**CERTIFICATE OF APPROPRIATENESS**

**Property:** 8339 Glencrest St., Lot 10, Block 12, Glenbrook Valley Section 4, Houston, Texas 77061

**Proposal:** Project Type Alteration – rear porch and reroof

**PROPOSED ROOF PLAN**

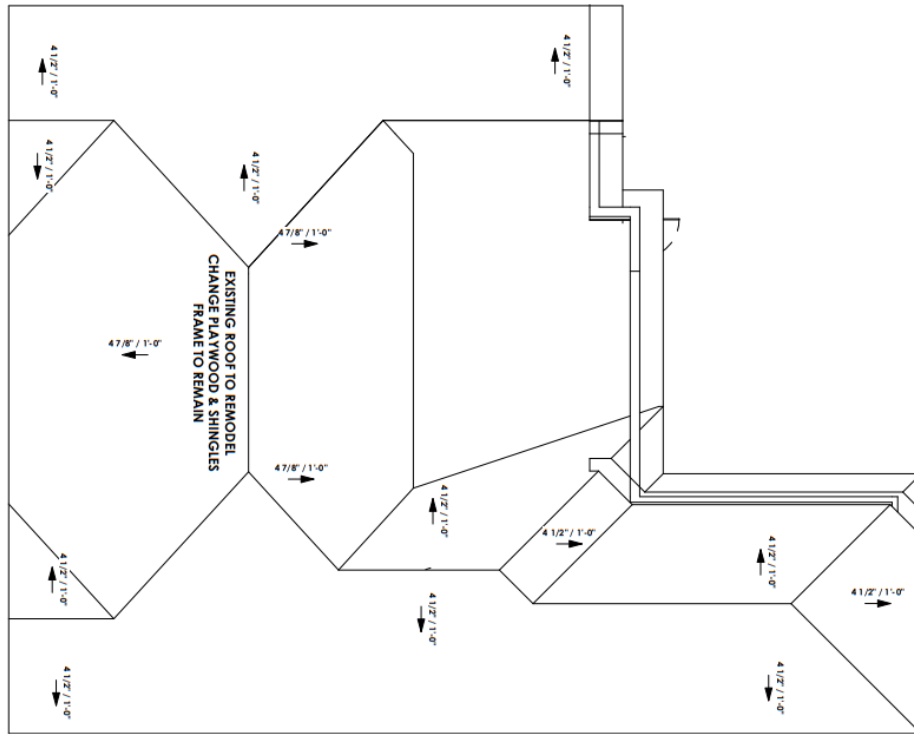
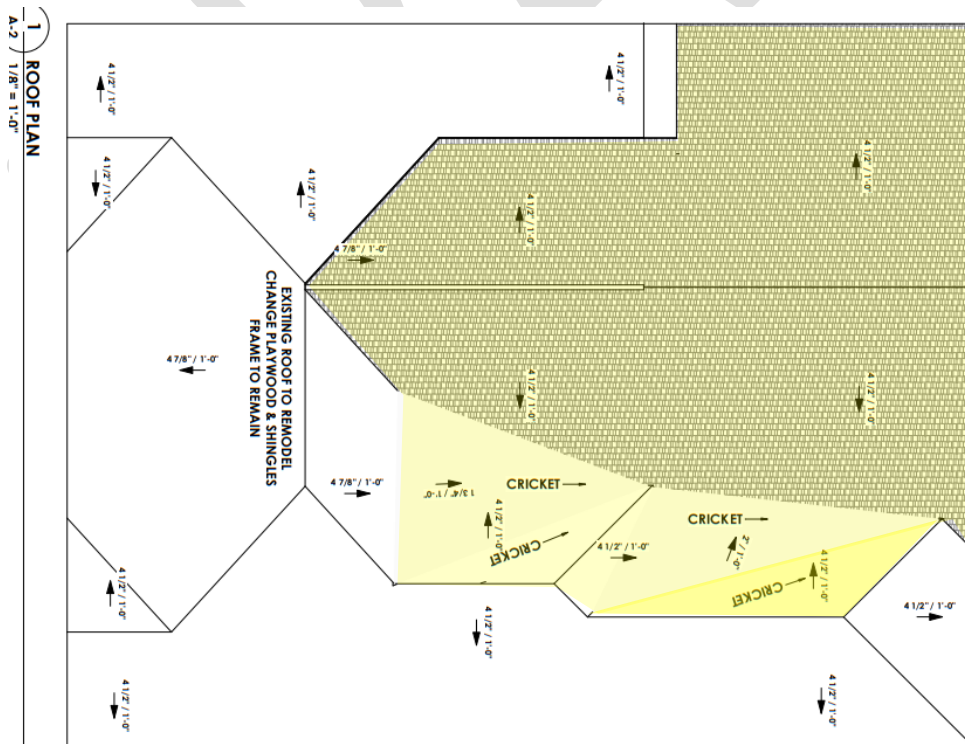
| <input type="checkbox"/>            | <input checked="" type="checkbox"/>                                 | <input type="checkbox"/>            | (6) New materials to be used for any exterior feature excluding what is visible from public alleys must be visually compatible with, but not necessarily the same as, the materials being replaced in form, design, texture, dimension and scale;<br><i>Proposed roof form is not typical of contributing context (rear gable porch extended from existing ridge) should start slightly lower than existing height to differentiate from historic roof. If ridge height is dropped, historic form would be more prominent.</i> |
| <input type="checkbox"/>            | <input checked="" type="checkbox"/>                                 | <input type="checkbox"/>            | (10) The proposed alteration or addition must be compatible with the massing, size, scale material and character of the property and the context area; and<br><i>Proposed roof form and massing is not typical of contributing context (rear gable extended from existing ridge) should start slightly lower than existing height to differentiate from historic roof. If ridge height is dropped, historic form would be more prominent</i>                                                                                   |

**Recommendation:** Approval with conditions: ridge height of proposed roof be lower than existing.
